Post Opening Road Safety Audit Report

Collins Street, Hobart TAS – Bicycle Lane Trial

Final2 Report 21/08/2026

28/07/2026 260013-SKT-05
3:46:18 PM T:\2627 Projects\260013-CTP-01-P1.dgn

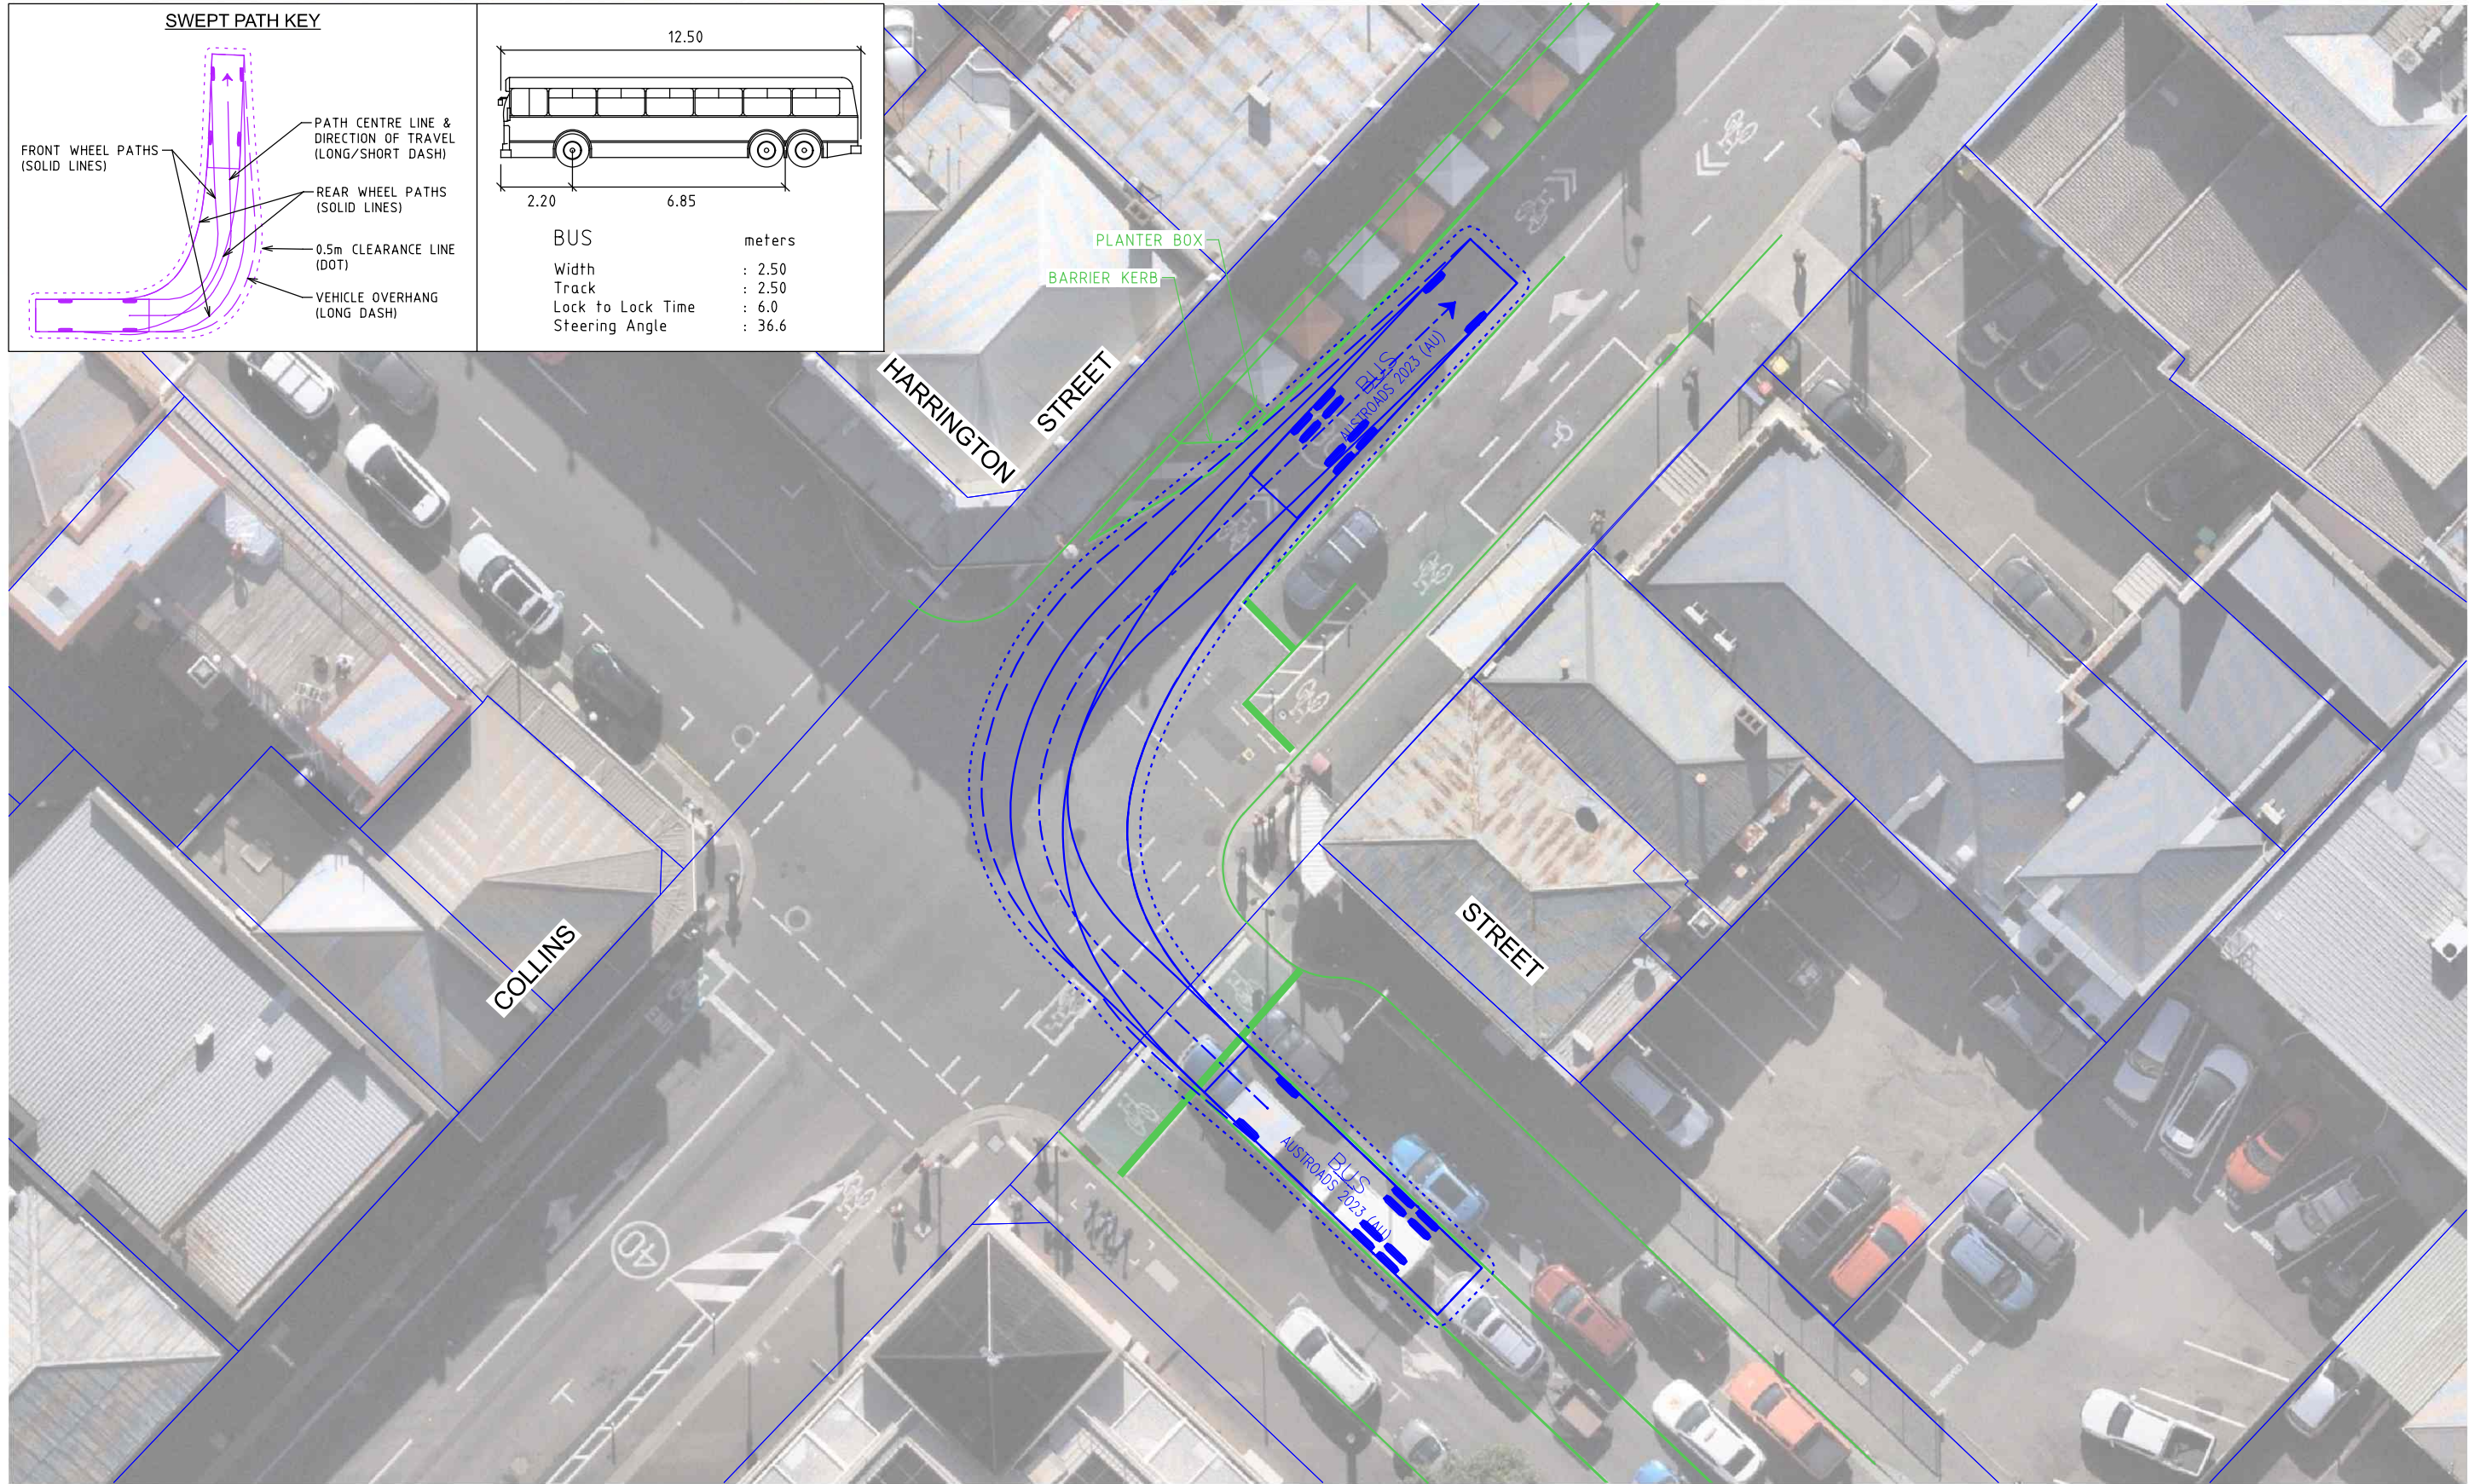
1.3.	Buses turn right from Harrington Street into Collins Street. Buses were observed turning from the central lane and requiring to significantly slow down to complete the turn. Swept path assessment (refer to Appendix 3 – Swept path assessment) indicates that prior to the installation of the outdoor dining area, buses could turn into Collins Street from the kerbside traffic lane. The impact to the bus turning swept path increases the risk of: — buses side swiping roadside furniture or southbound vehicles at the hold line on Collins Street — rear end collisions for trailing vehicles on Harrington Street who are not expecting buses to significantly slow down during their turn.	Remove part of the outdoor dining kerb outstand to ensure buses can turn right from Harrington Street into Collins Street from the kerbside lane (P)	Likelihood: Likely Severity: Insignificant Risk rating: MEDIUM Safe system energy: Below tolerance
